**NEW YORK STATE THRUWAY AUTHORITY
DEPARTMENT OF ENGINEERING**

**ALBANY, NY
JANUARY 30, 2024**

**AMENDMENT NO. 2
TO**

**CONTRACT TAA 23-25B
D214941
THRUWAY BRIDGE REHABILITATION
OVER THE WALLKILL RIVER, MP 81.72
IN THE ALBANY DIVISION
OF THE NEW YORK STATE THRUWAY
IN ULSTER COUNTY**

THIS SHEET SUPERSEDES SHEET 55
IN ITS ENTIRETY

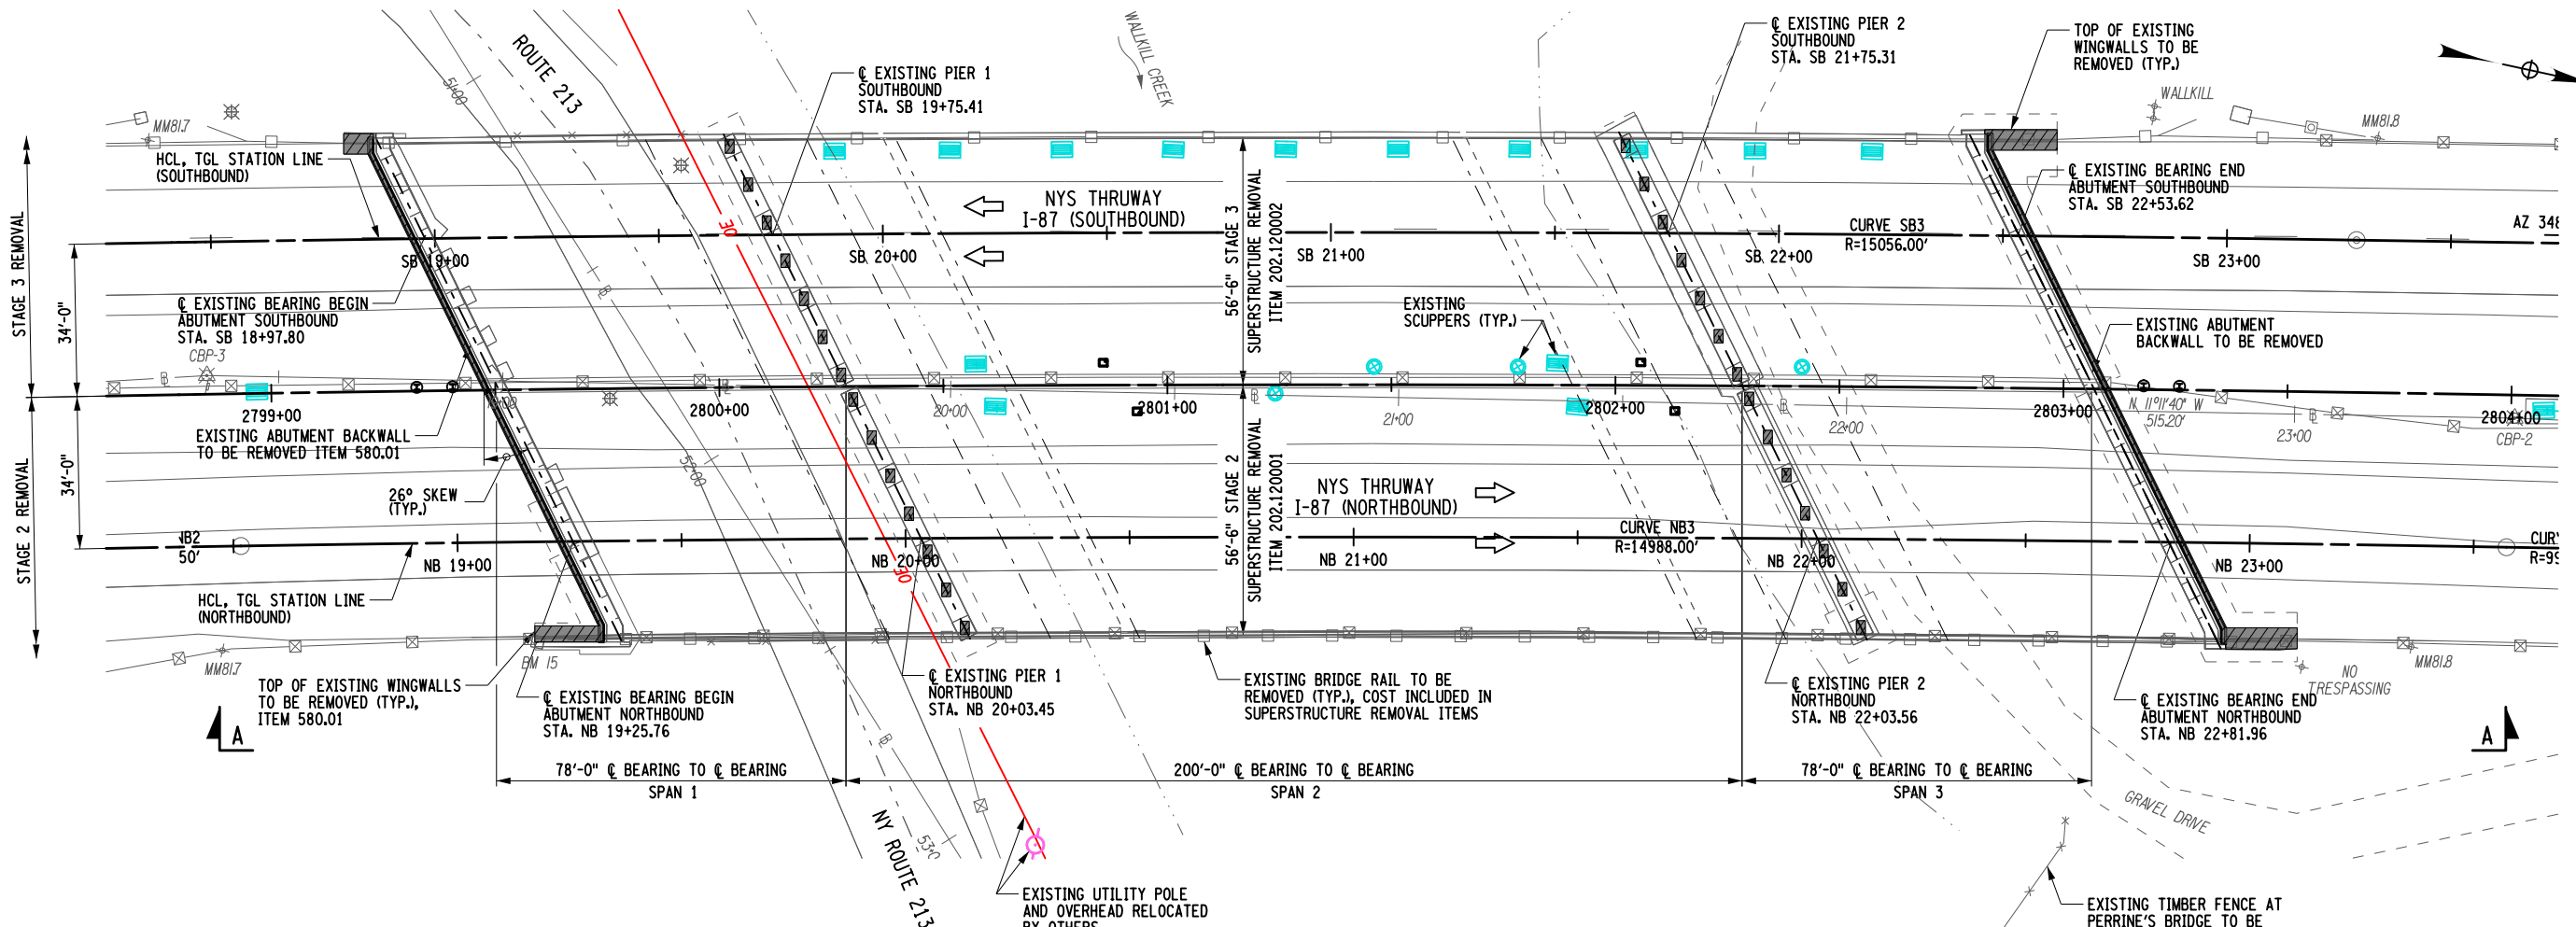
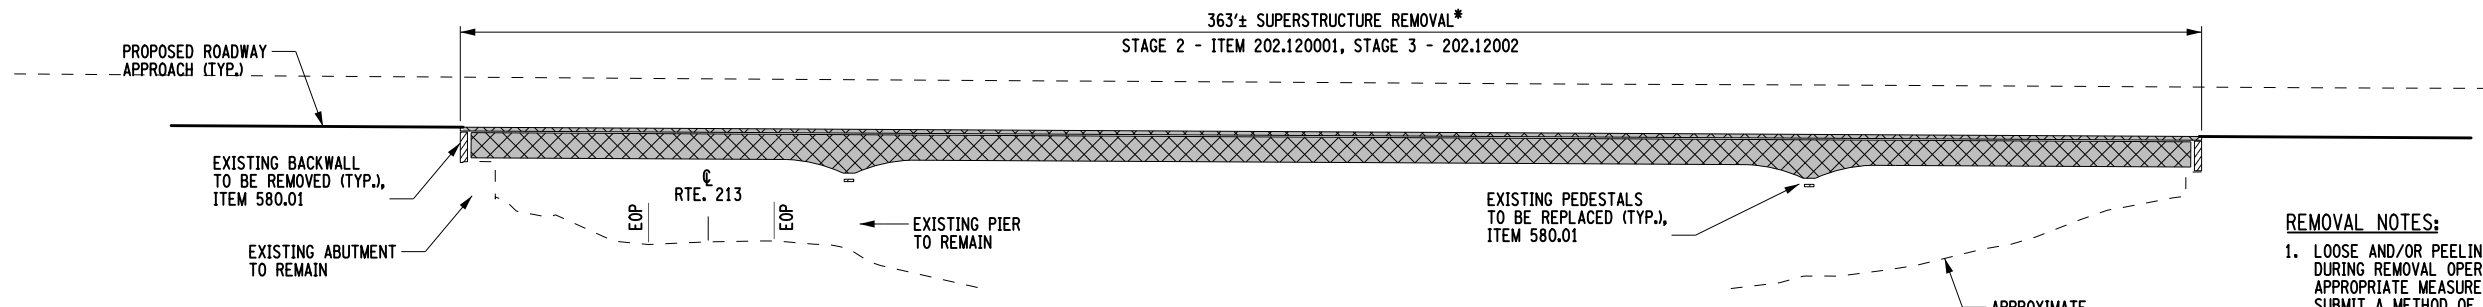
31. **DELETE** Drawing Number ST-14, Sheet 55 of 105 and **REPLACE** with the attached new Drawing Number ST-14-A2, Sheet 55-A2 of 105.
 - Notes have been added to identify lead paint on existing girders

TITLE OF PROJECT I-87 OVER WALLKILL RIVER BRIDGE REHABILITATION	CONTRACT NUMBER: TAA 23-25B
LOCATION OF PROJECT ALBANY DIVISION MP 81.72 - BIN 5041189	DATE: 01/24/2024
TITLE OF DRAWING PROPOSED BACKWALL SECTIONS	DRAWING NUMBER: ST - 26

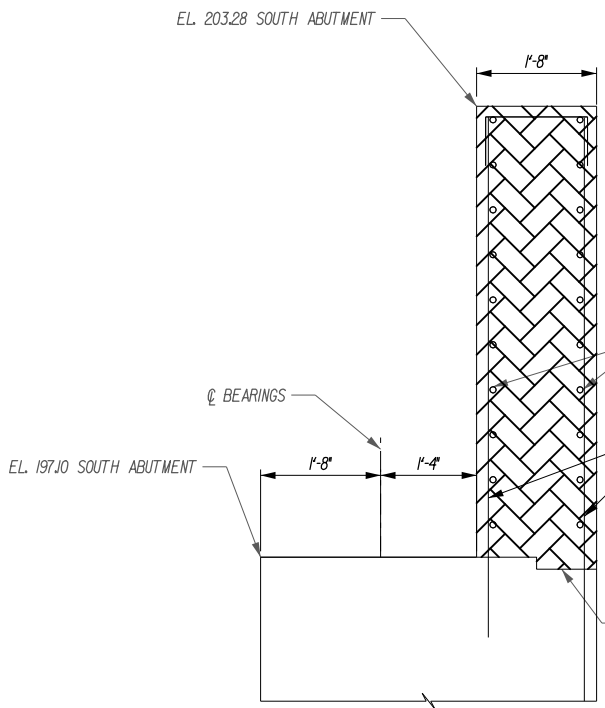
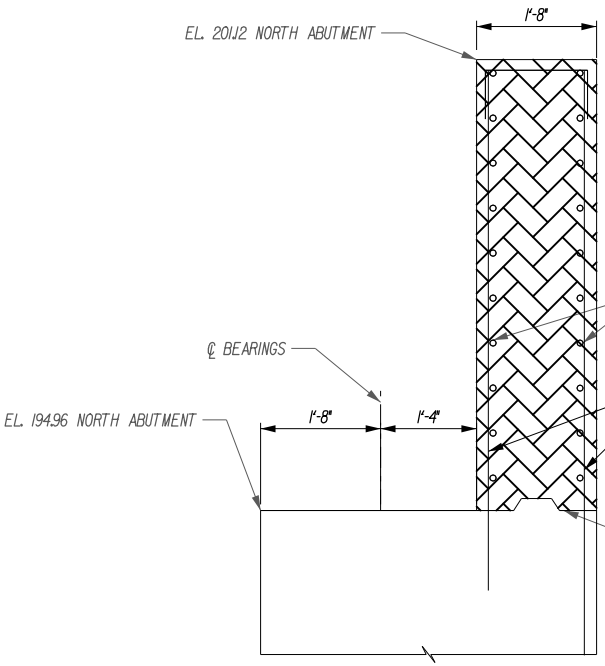
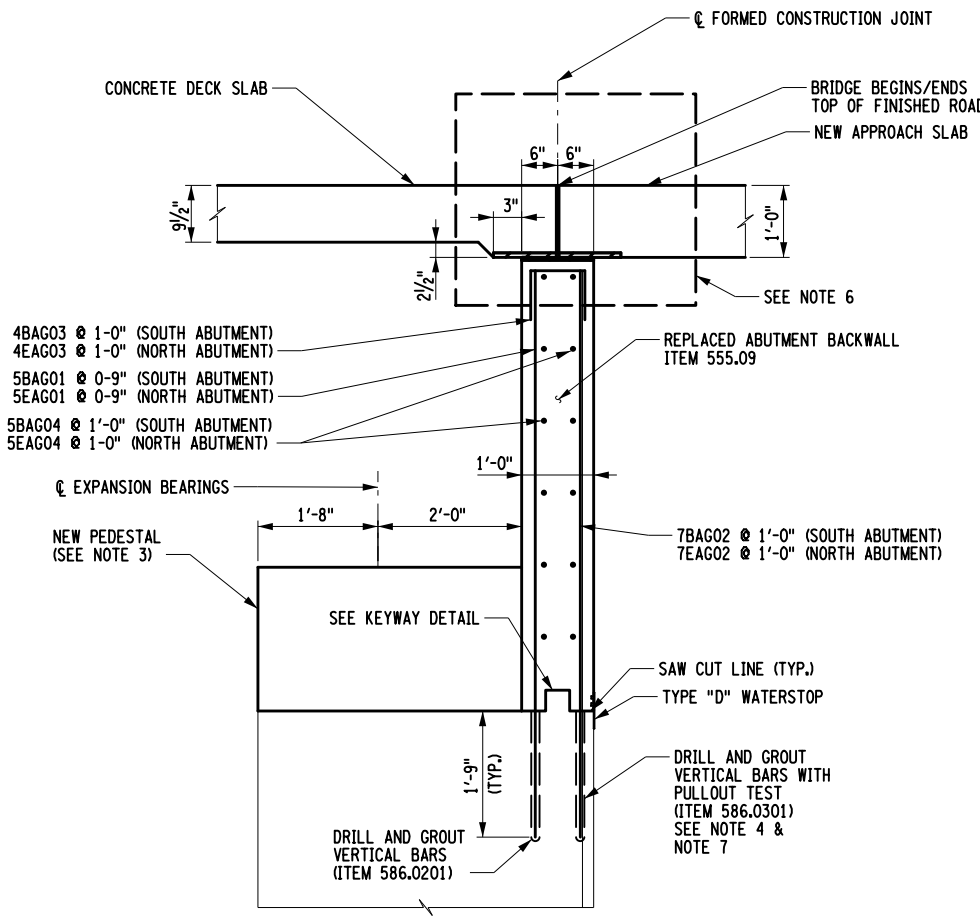
- A callout was added to correctly identify an item number for drilling and grouting of rebars with pull out testing
 - A new Note 7. has been added to provide information for the drilling and grouting (and with pull out testing) items

- A new Type D Waterstop Detail has been added to the top right corner of the drawing
44. **DELETE** Drawing Number ST-28, Sheet 69 of 105 and **REPLACE** with the attached new Drawing Number ST-28-A2, Sheet 69-A2 of 105.

TITLE OF PROJECT I-87 OVER WALLKILL RIVER BRIDGE REHABILITATION	CONTRACT NUMBER: TAA 23-25B
LOCATION OF PROJECT ALBANY DIVISION MP 81.72 - BIN 5041189	DATE: 01/24/2024
TITLE OF DRAWING EXPANSION ELASTOMERIC BEARING DETAILS	DRAWING NUMBER: ST-28

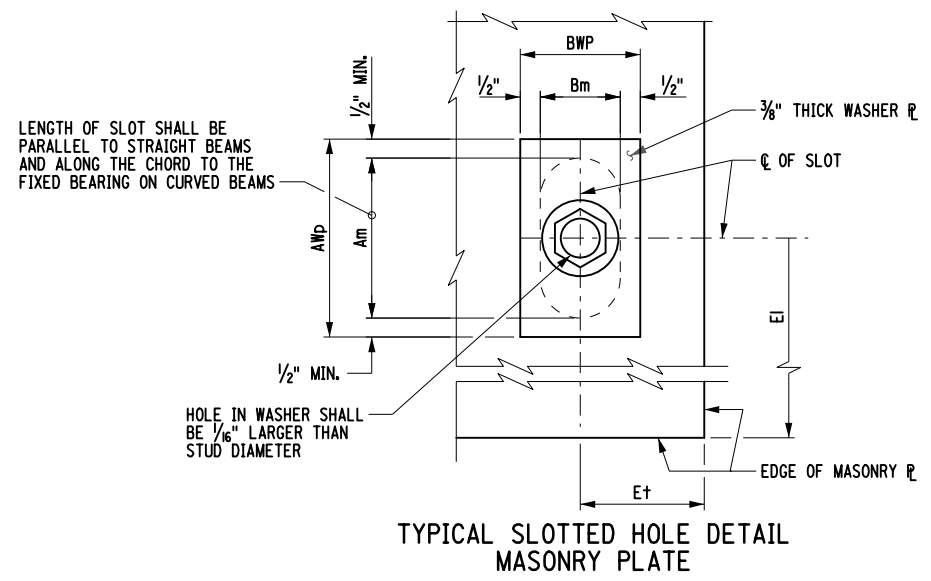
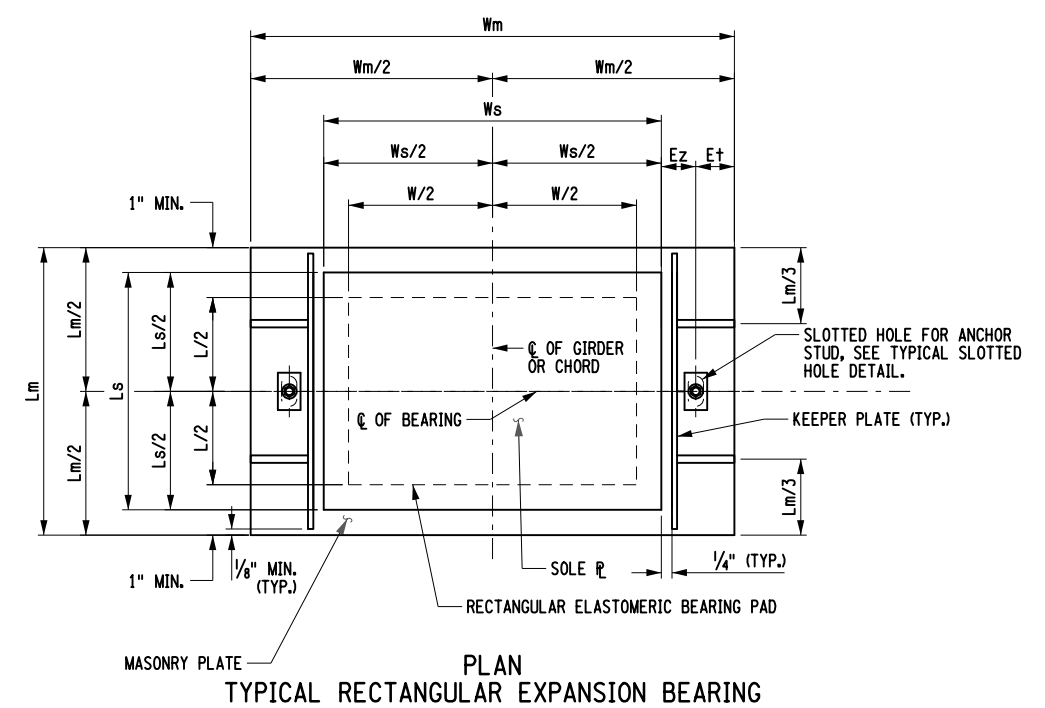
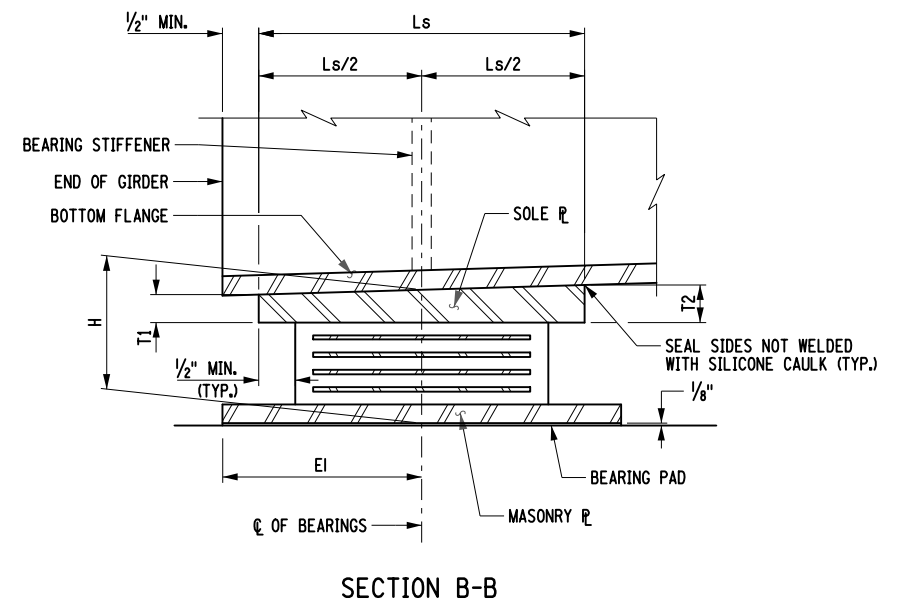
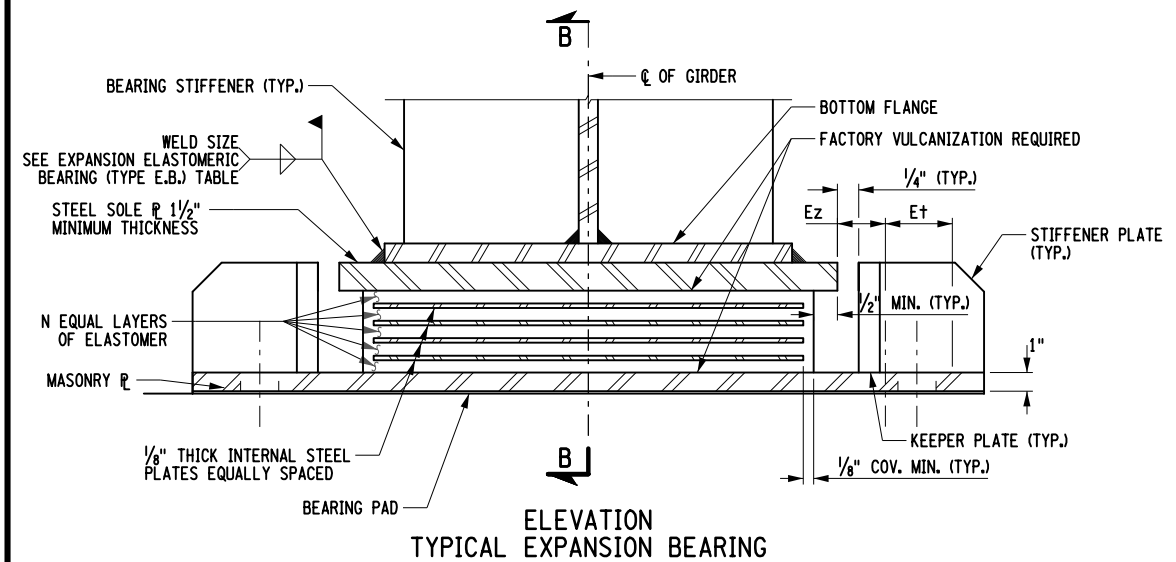
- Keeper plate details have been added below the Notes
 - On the Bearing Table, the Ez and Et Values and Width of Masonry Plate have been updated
 - A Keeper load column was added before the Shape Factor column

- A New Note 14. has been added regarding the keeper plate height
45. **DELETE** Drawing Number ST-30, Sheet 71 of 105 and **REPLACE** with the attached new Drawing Number ST-30-A2, Sheet 71-A2 of 105.

THIS SHEET SUPERSEDES SHEET 75
IN ITS ENTIRETY

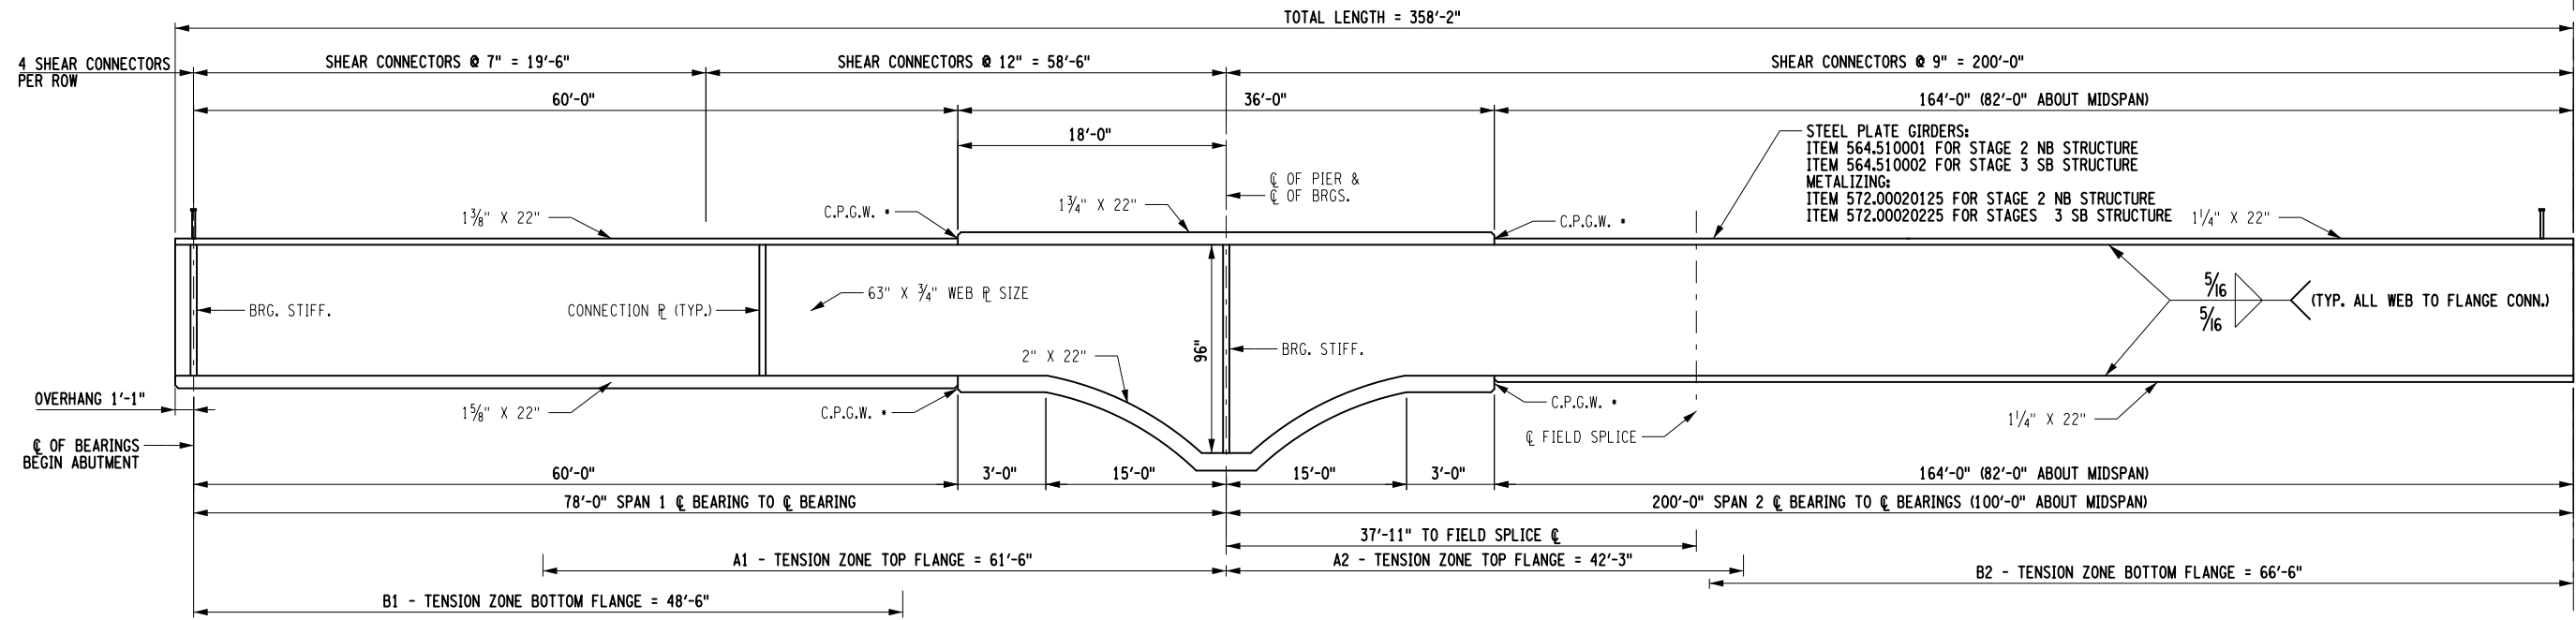
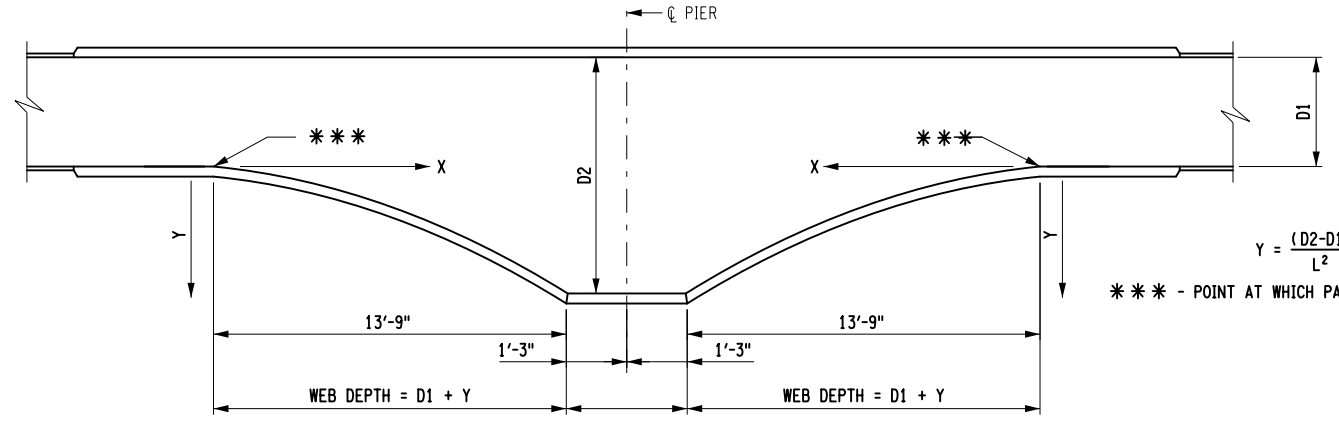
47. **DELETE** Drawing Number ST-34, Sheet 75 of 105 and **REPLACE** with the attached new Drawing Number ST-34-A2, Sheet 75-A2 of 105.
 - Note 4 has been revised for where welding is allowed, for the removal of metalizing to perform welding

THIS SHEET SUPERSEDES SHEET 82
IN ITS ENTIRETY

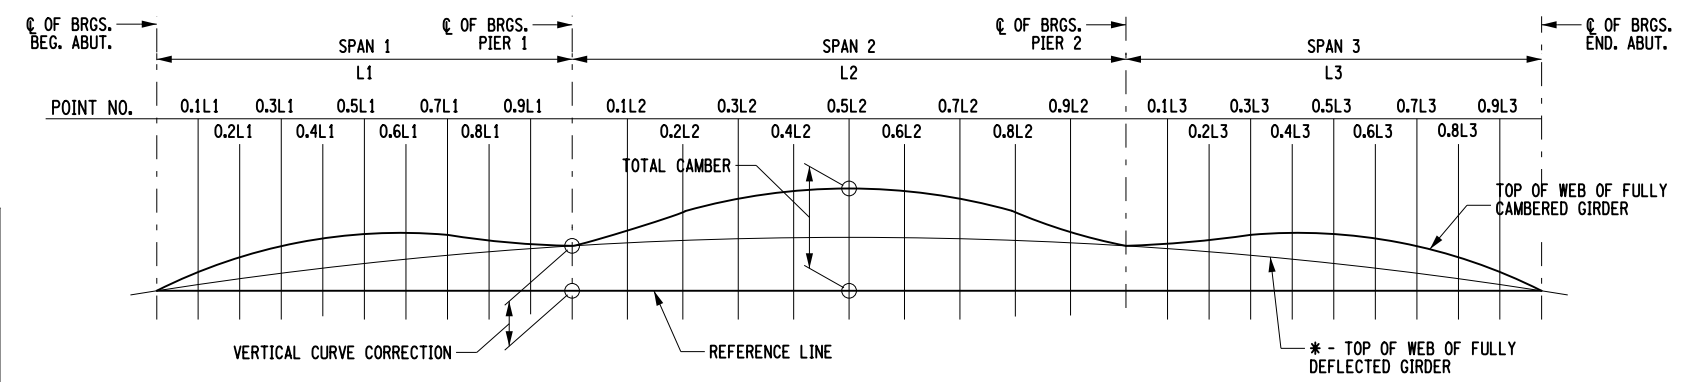
48. **DELETE** Drawing Number ST-41, Sheet 82 of 105 and **REPLACE** with the attached new Drawing Number ST-41-A2, Sheet 82-A2 of 105.
 - The Northbound Camber Table values have been updated
